NUMBER: 23-051-15

Liftgate Open Indicator Illuminated And Liftgate Will Not Latch Fully

This bulletin involves replacing the liftgate bumpers, liftgate weatherstrip, and adjusting the liftgate latch.

Fiat 500X

Fig. 4 Liftgate Striker Cover

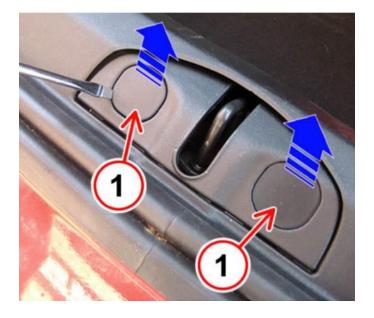
- 6. Is the liftgate open indicator illuminated and/or does the liftgate not close fully? a. YES>>> Continue with the Repair Procedure Step #7.
 - b. NO>>> This bulletin has been completed.
- 7. Remove the liftgate striker fastener covers (1) (Fig. 4).

- 11. Verify proper liftgate latch operation.12. Install the liftgate striker fastener covers (1) (Fig. 4).
